MECKLENBURG COUNTY
DEPARTMENT OF ENVIRONMENTAL HEALTH

APPLICATION FOR SOIL INVESTIGATION

SITE INVESTIGATION REPORT
INDIVIDUAL SEPTIC TANK SYSTEM
WITH SUBSURFACE,
SOIL ABSORPTION,
EFFLUENT DISCHARGE

SIR.NO. 16203
T.C.NO 113-181-07
MAP DATE
DATE Nov. 1, 1979

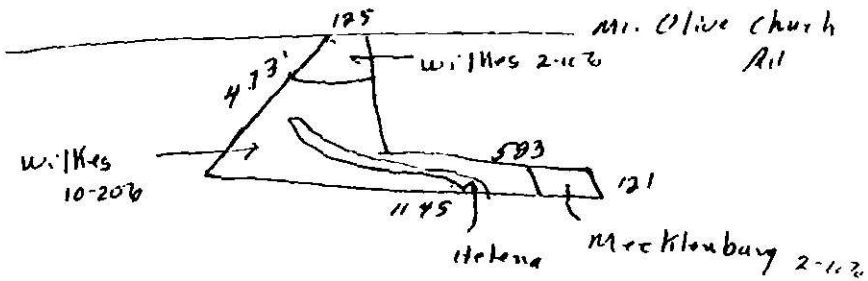
125
Mt. Olive Church Rd
Wilkes 2-1126
473'
Wilkes 10-2076
593
121
1145
Helena
Mecklenburg 2-1126

Soil Structure Massive
Soil Permeability Unsuitable

Sites classified as Unsuitable are not acceptable for soil absorption of sewage effluent. However, if engineering, geologic, soil, and environmental studies indicate that a suitable septic tank system or a suitable alternate system can be expected to function satisfactorily, such sites may be re-classified as Provisionally Suitable. (Section 10 of the North Carolina Administrative Code 10 A,.1910)

If you desire to file for permission to install an "alternate or modified" system, you should present this office with your proposals in the form of plans and specifications. These would be reviewed and if it is found that the system may reasonably be expected to function satisfactorily, approval may be given on the execution by you of a "Septic Tank Agreement Form" available in this office.
